Report on
Inspection of Leaks and Cracks in the
(A) Steam Generator at H. B. Robinson II

Report No. DC 89

June 23, 1971

Prepared for: U. S. Atomic Energy Commission
Division of Compliance
AEC Contract AT (11-1)-1658
Subcontract No. 10

FIG. 1
"A" STEAM GENERATOR

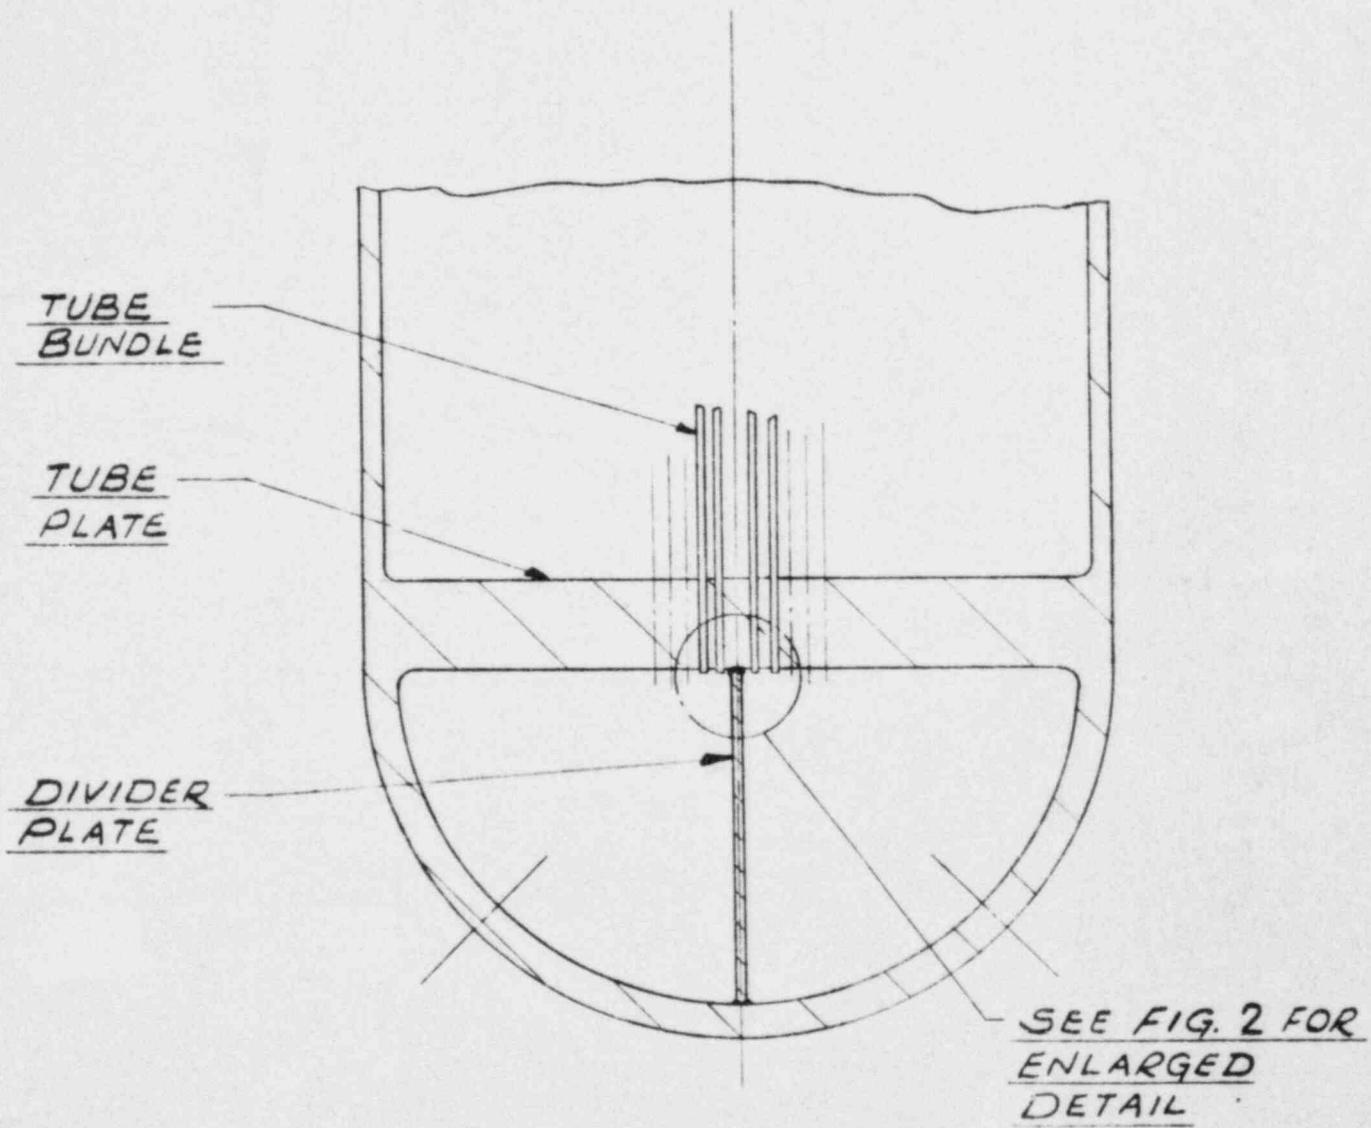
Mr. Kirkpatrick and the writer were "suited-up" and proceeded to enter individually and inspect the cold leg of the A steam generator. The inspection was performed visually using a low power magnifying lens. Mr. Kirkpatrick attempted to photograph the conditions we observed with a 35 mm. camera using a close-up lens. The following conditions were observed during this inspection: (See Figs. 1, 2 & 3)

- (1) Severe cracks were present in the fillet welds of approximately 30 tubes. The highest intensity of fillet cracking was apparent in the region included in and surrounding the 35th

These cracks were opened approximately .030 to .050 inches and were approximately semi-circular on the side of the fillet welds facing the flow divider plate.

- (2) Cracking in the 1/4 inch thick cladding was extensive in the region described above. These cracks were linear in the north-south direction (parallel to the divider plate) and were located approximately in line with the center of the first row of tubes. These cracks were tighter than those observed in the fillets and appeared to range in the vicinity of .005 to .010 inches wide and extended the entire length of the cladding between the cracked tubes.

- (4) The writer visually observed a contoured region of the cladding, adjacent to the divider plate and in the vicinity of the 40th to 50th tubes that showed definite signs of having been separated from the tube sheet.

FIG. 2
ENLARGED VIEW OF
CLAD SEPARATION

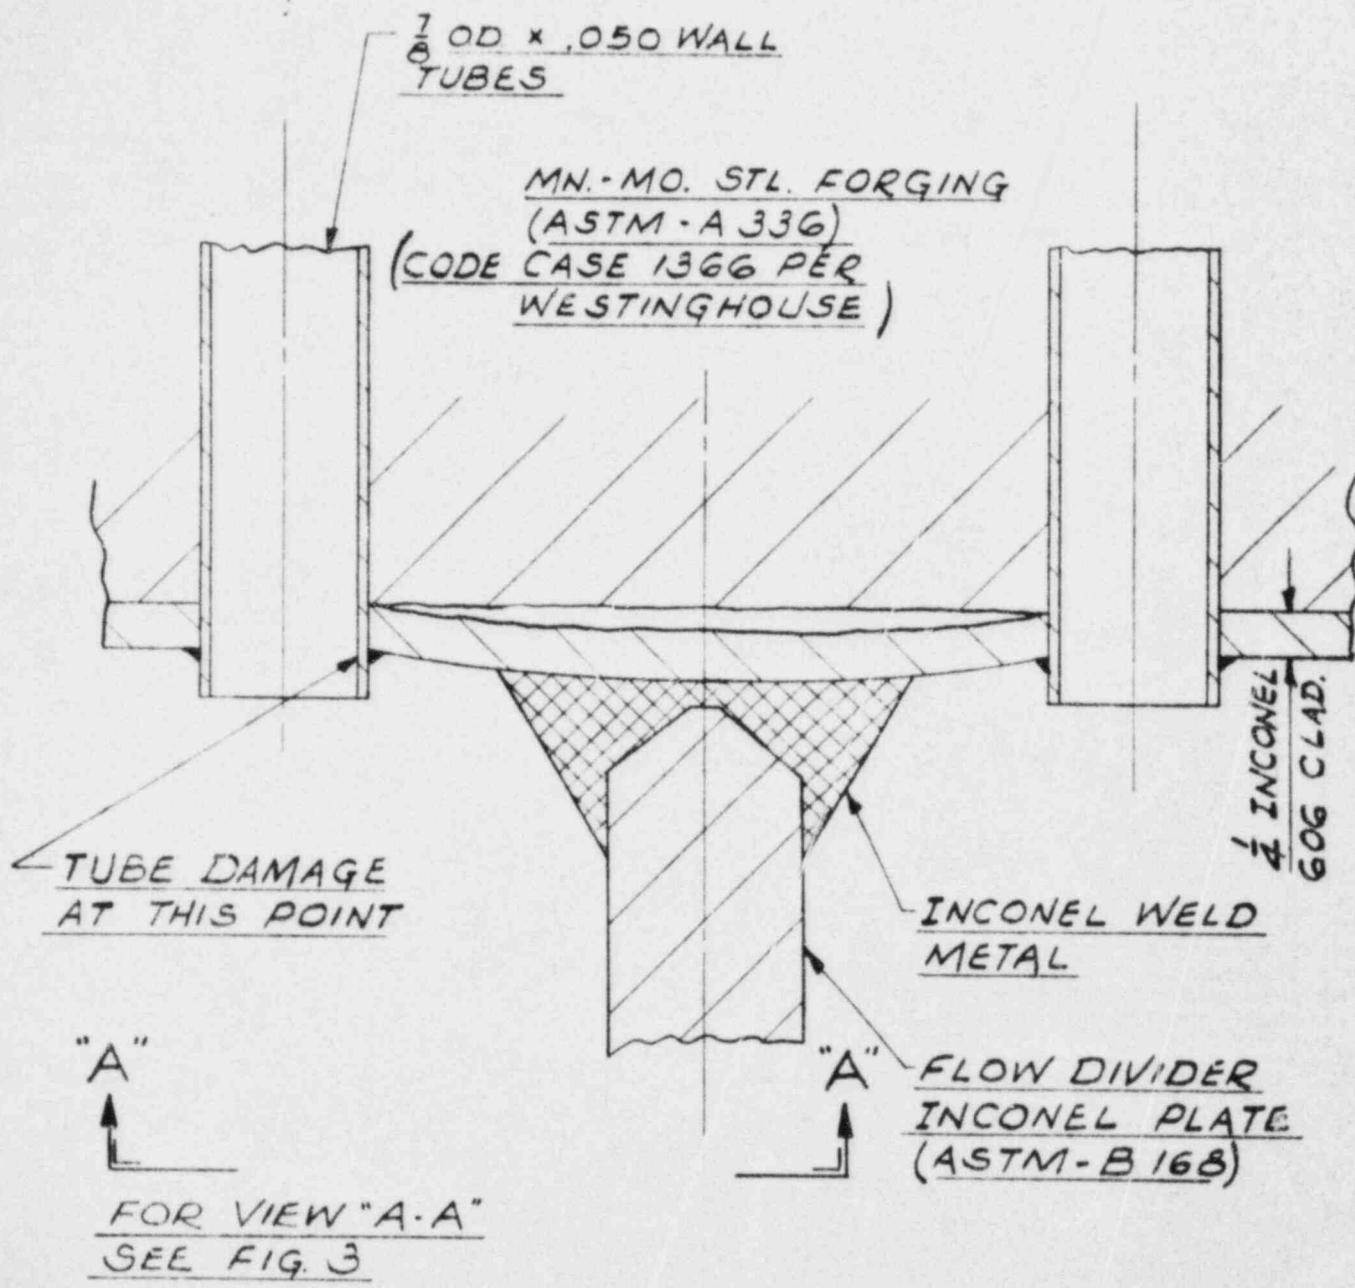
APPROX. .030 TO .050
WIDE CRACKS IN
FILLET WELDS APPROX.
SEMI-CIRCULAR ON THE
SIDE OF WELDS FACING
THE FLOW DIVIDER
PLATE.

APPROX. .005 TO .010
WIDE CRACKS IN
CLADDING APPROX.
ON $\frac{1}{2}$ OF TUBES
EXTENDING THE
ENTIRE LGTH.
BETWEEN TUBES.
